August 2020  
FL834A-F  
NHTSA #19V-722  
Transport Canada #19-508

## **Subject: Western Star Baggage and Sleeper Doors**

**Models Affected: Specific Model Years 2017-2020 Western Star 4900 and 5700 model vehicles manufactured November 14, 2016, through September 12, 2019, and equipped with certain baggage and sleeper doors.**

**Fig. 1, Door Flange Trim Location**

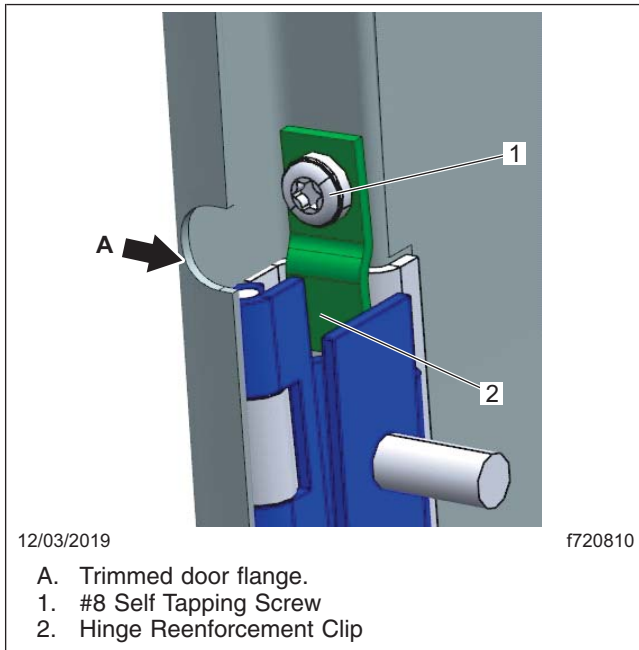
5. Mark out the areas of the door flange to be trimmed to allow tool access for a #8 self tapping screw. See **Fig. 1**, ref. **A**.
  - 5.1 Holding the bracket in place, mark the outer flange using the fastener hole in the bracket as a guide. This mark will be the centerline of the tool access notch.
6. Notch the door flange surface. See **Fig. 2**.
  - 6.1 Using a rotary tool, cut a 10mm circular notch in the flange, extending the notch halfway down the flange.

**Fig. 3, Door Hinge Trim Location**

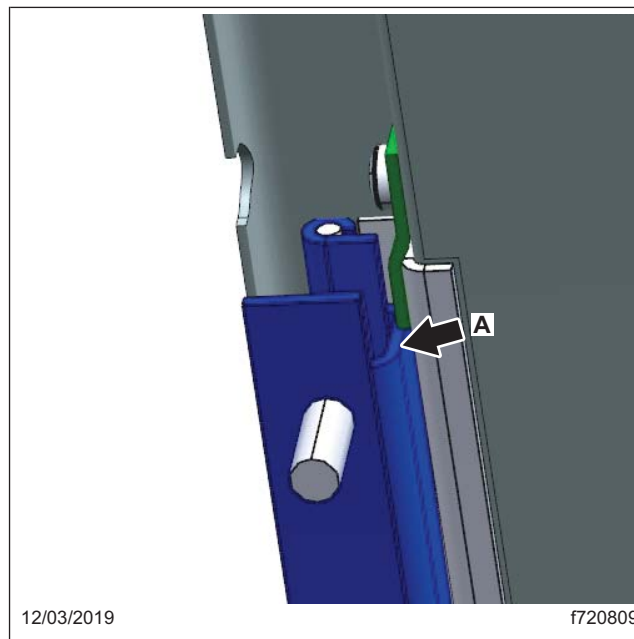
7. Mark out the areas of the door hinge that will need to be trimmed to allow clearance for the new clip. See **Fig. 3**, ref. **A**.
8. Trim the door hinge as shown in **Fig. 3**. Trimming past the bend in the hinge to allow full range of motion.

**Fig. 4, Hinge Reinforcement Assembly**

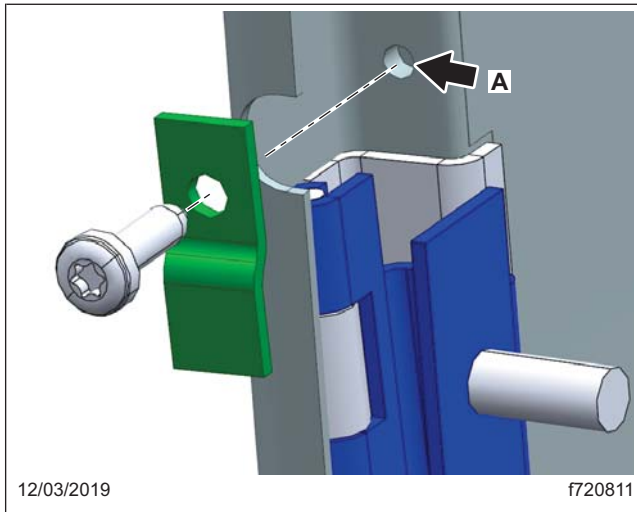
9. Install the new clips to the top and bottom of the hinge using #8 self tapping screws and tighten the screws to 10 lb-in (113 N-cm) and not to exceed 2500 rpm. See [Fig. 4](#) and [Fig. 5](#)
